Groundwater and Wastewater Services File Imaging Project

Mecklenburg County
Health Department

Re: Rozzelles Ferry Road
File: 1536A
Parcel: 023-132-01

PROPOSED PLOT PLAN

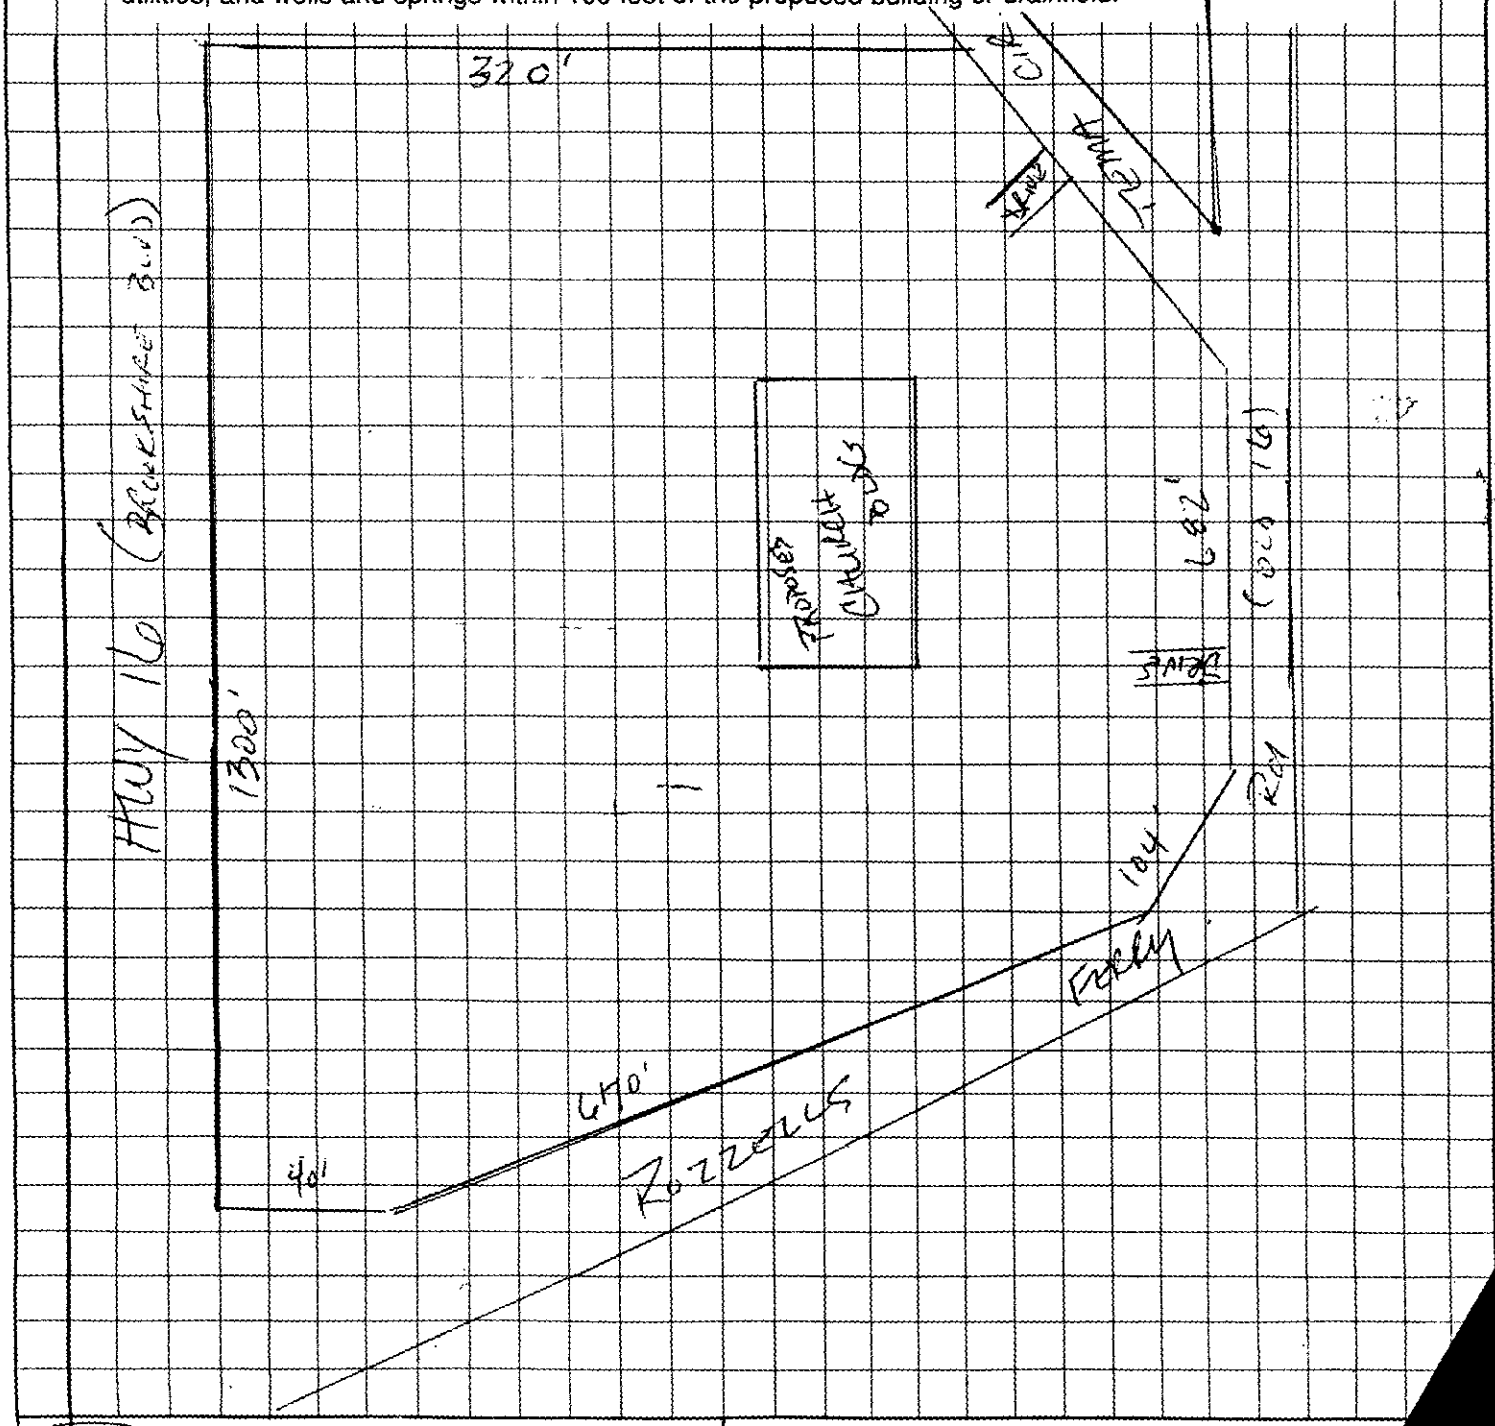
Receipt of the plans and specifications for a conventional system of sewage treatment and disposal for the above property is hereby acknowledged. Upon receipt of the information, a review was made of the material on file and a site evaluation was conducted. The plan was then reviewed in conjunction with provisions of 15A NCAC 18A .1900, "Laws and Rules for Sewage Treatment and Disposal Systems." Our comments are listed below (see enclosed soil report):

1- The available area on this site is classified as **UNSUITABLE** according to the following rules:

(a) .1945 Available Space

For these reasons, the plans as submitted are disapproved.

Possible ways to develop this site includes submittal of a plan for a Prefabricated, Permeable Block Panel System (PPBPS). These plans would also need to include appropriate surface water diversions. Enclosed is a copy of Rule .1956 Modifications to Septic Tank Systems pertaining to PPBP Systems. This system would require a pump and a maintenance agreement. This system would be required to be designed by a consultant or engineer and the plans submitted to the Health Department for approval.

SOIL/SITE EVALUATION
for ON-SITE WASTEWATER SYSTEM

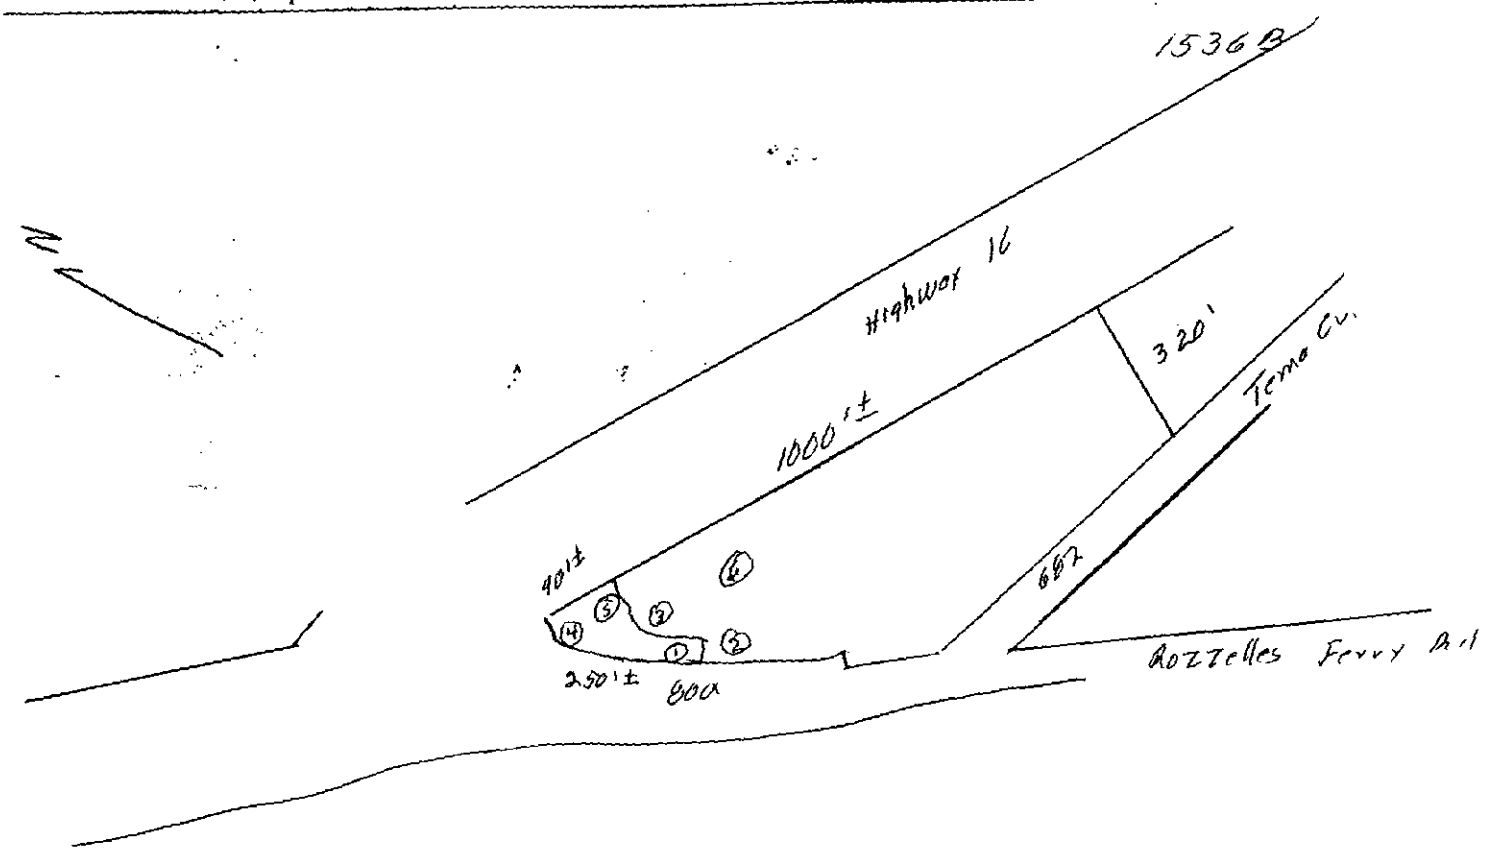
DESCRIPTION	INITIAL SYSTEM	REPAIR SYSTEM
Available Space (.1945)	US	US
System Type(s)

OTHER FACTORS (.1946):
SITE CLASSIFICATION (.1948): Unsuitable
EVALUATED BY: William A. Marks 6-29-96
OTHER(S) PRESENT:

SOIL/SITE EVALUATION
for ON-SITE WASTEWATER SYSTEM

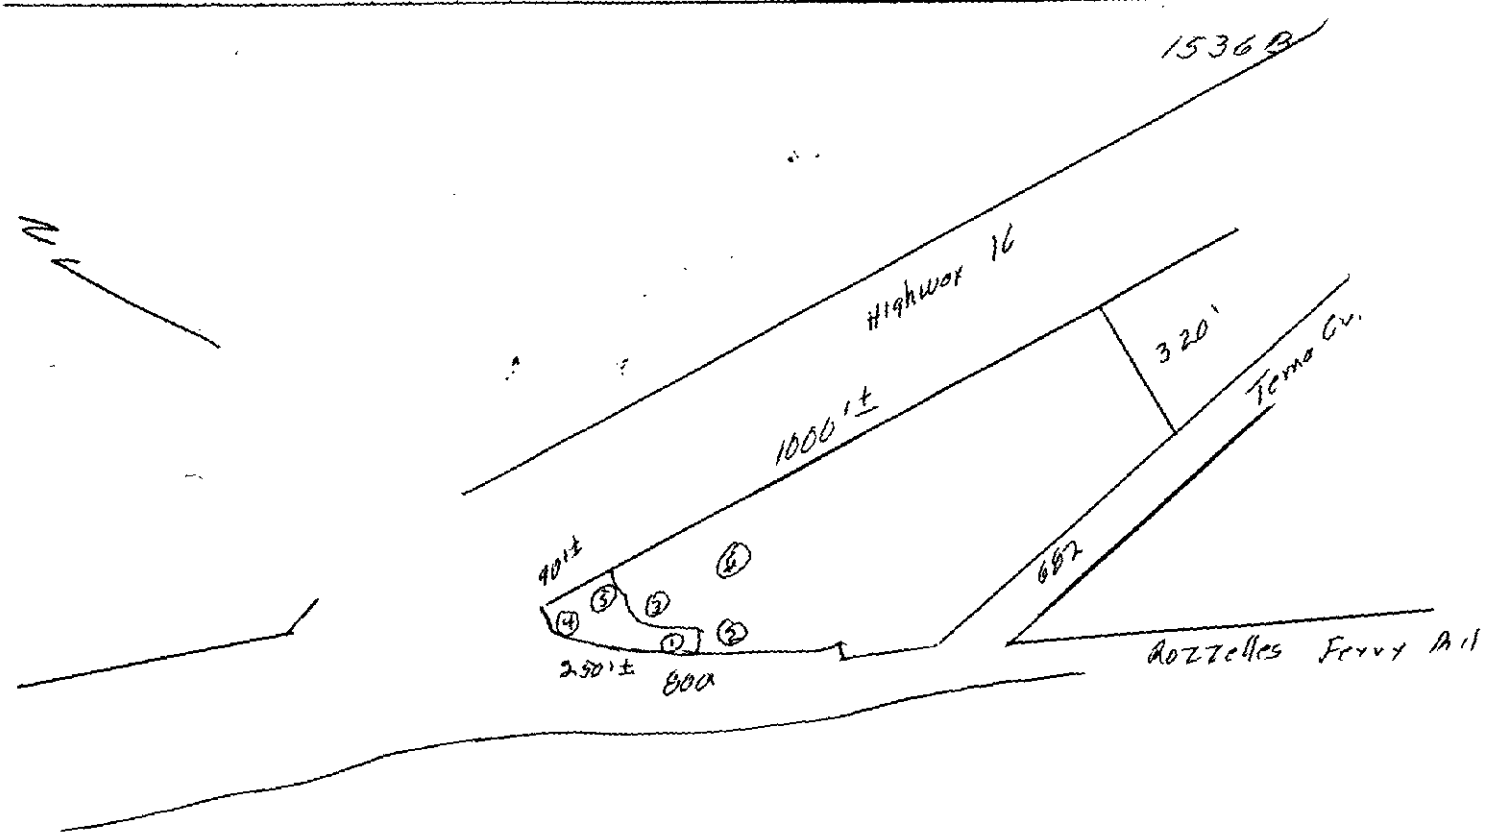
DESCRIPTION	INITIAL SYSTEM	REPAIR SYSTEM
Available Space (.1945)	US	US
System Type(s)		
Site LTAR

OTHER FACTORS (.1946):
SITE CLASSIFICATION (.1948): Unsuitable
EVALUATED BY: William A. Marlin 6-29-96
OTHER(S) PRESENT:
